MP10_160 Mod 6 White Rock Wind Farm (WRWF) - Further Information

This letter has been prepared by White Rock Wind Farm Pty Ltd (WRWFPL) in response to the Department's request for further information (RFI, email dated 21 November 2018), to address additional comments received from the Office of Environment and Heritage (OEH) and the Roads and Maritime Service (RMS).

1. OEH Request for Further Information (Letter dated 5 November 2018)

2. RMS Request for Further Information (Email dated 8 November 2018)

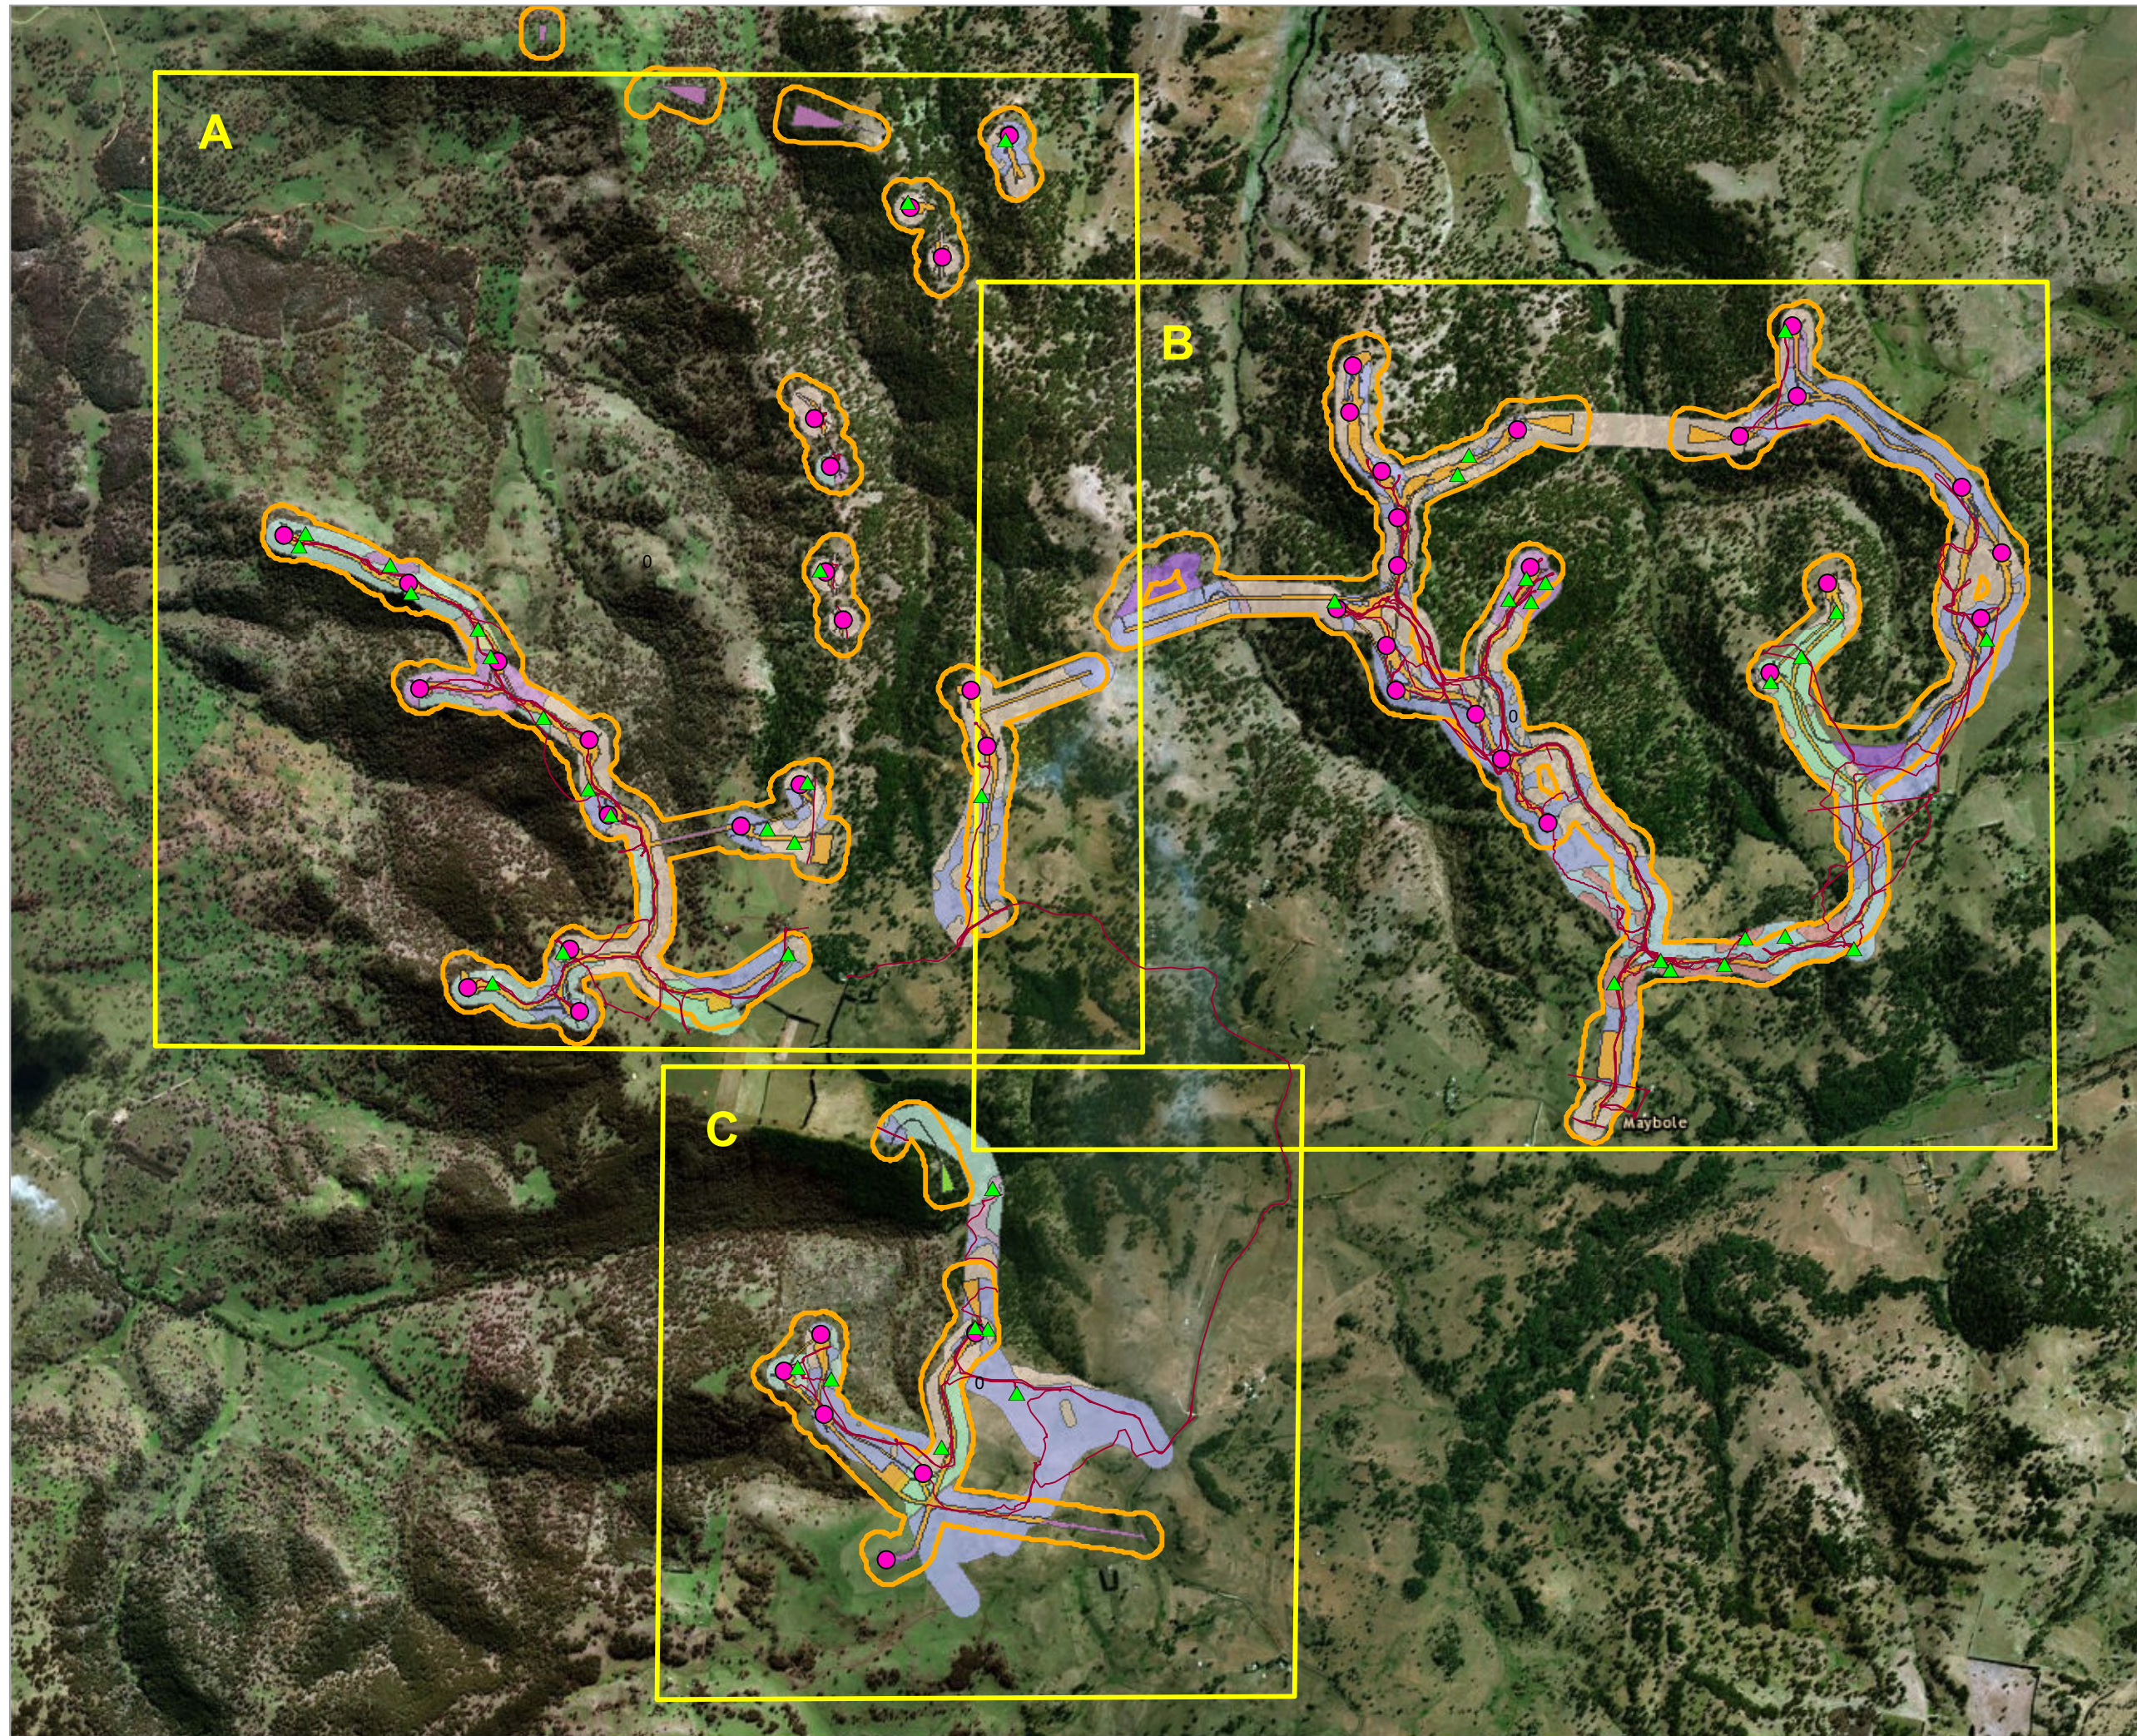
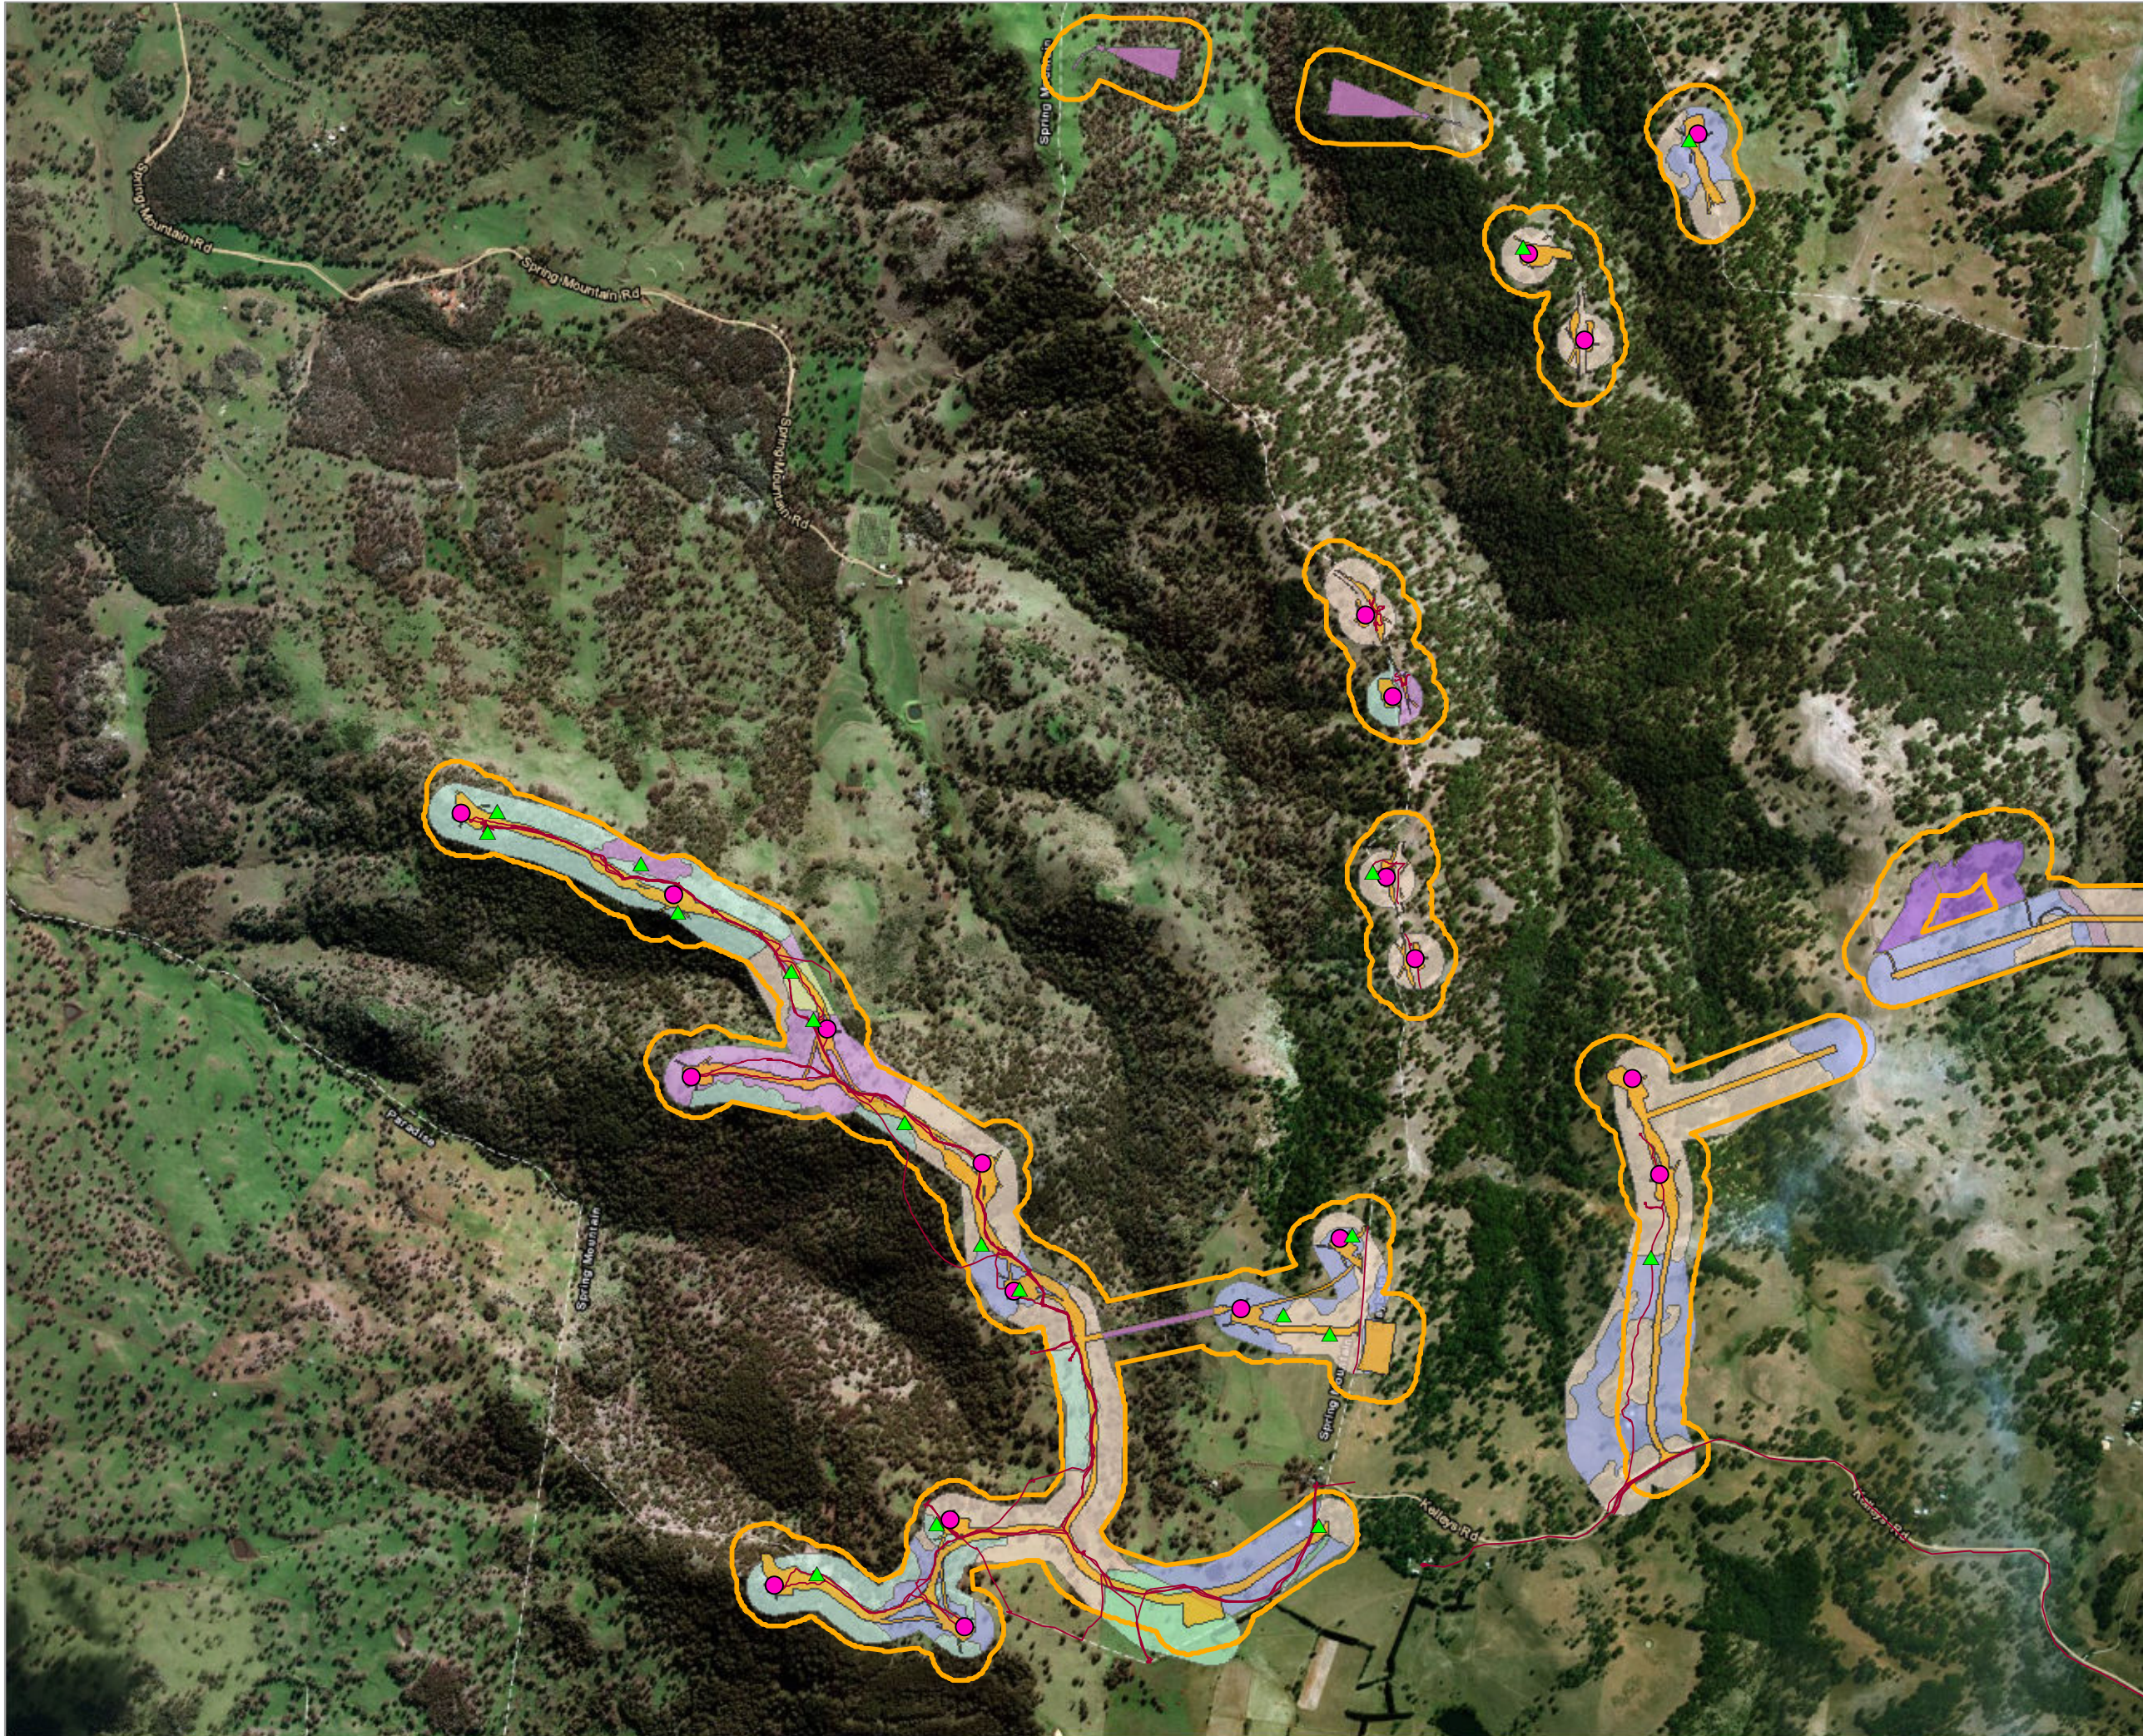
5	Inconsistent reflection of flora sampling methodology Figure 4-1 within the BAR appears to be inconsistent with the sampling description provided in text and the requirements of the 'NSW Guide to Surveying Threatened Plants'.	Figure 4-1 of the BAR shows the location of threatened flora surveys, however as detailed in Section 4.5.2, three people were involved in each of the threatened species surveys, meaning that a width of 30 m per transect was covered in each of the mapped transect. Maps of our GPS tracks, marking the central transect, are provided with this letter (Attachment 2). Note that a number of survey tracks are not able to be mapped. As discussed above, these surveys were undertaken within areas determined as a higher likelihood of occurrence for the target species, based on habitat quality, within the access track easements and wind turbine pad footprints. These surveys combined with the analysis of records within the broader locality are considered adequate to have detected the presence of threatened flora species within the development envelope.				NGH Environmental proposed way forward: Ask OEH to reconsider adequacy with reference to Table 2's justification of any deviations from FBA.

However, Figure 4-1 contained within the BAR illustrates targeted flora survey tracks which do not appear to reflect the methodology outlined above, and which appears to be inconsistent with the sampling description provided in text and the requirements of the '*NSW Guide to Surveying Threatened Plants*'.
